United States Department of the Interior

BUREAU OF LAND MANAGEMENT

Date: 08/20/10
To: Minerals Files UTU-69800, UTU-69812
From: Ted McDougall, Geologist
Subject: Surface Management Site Inspection, Denison Mines (USA) Corp, La Sal Mines (Pandora – UTU69800/M0370012; LaSal, Snowball and Beaver– UTU69812/M0370026), San Juan County, Utah.

Pandora Mine. Top - Trash dumped on the top of the waste rock pile; Bottom – nearly empty trash container.

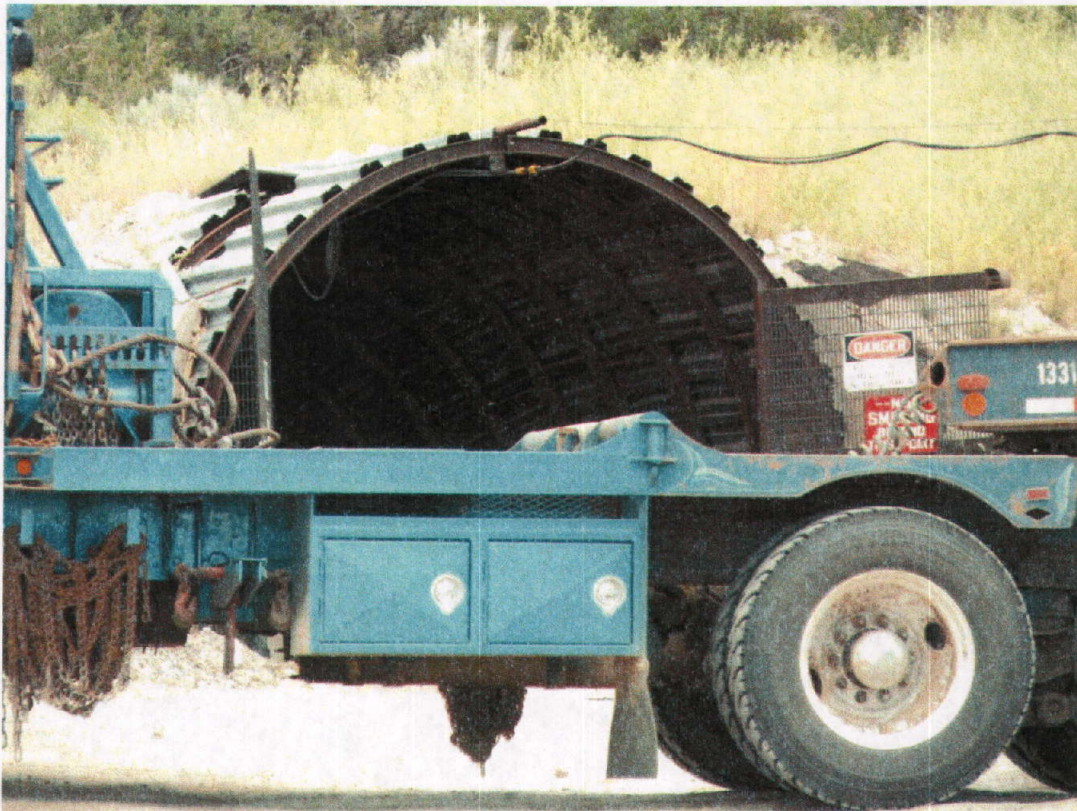
Other – A pile of discarded mine debris including, brattice, pallets, chain link, and common trash was located on top of the waste rock dump. We noted that the on-site trash container was nearly empty. We immediately went to the mine office and Danny talked to the mine foreman about the incident. He stressed that disposal of trash in the waste rock dump was not an acceptable practice. Before we left the site, a loader was dispatched to clean up the site.

- Denison Mines should continue to monitor its waste rock dumps to ensure that all trash is placed in the intended trash containers. All trash should then be hauled off site to an authorized disposal facility.
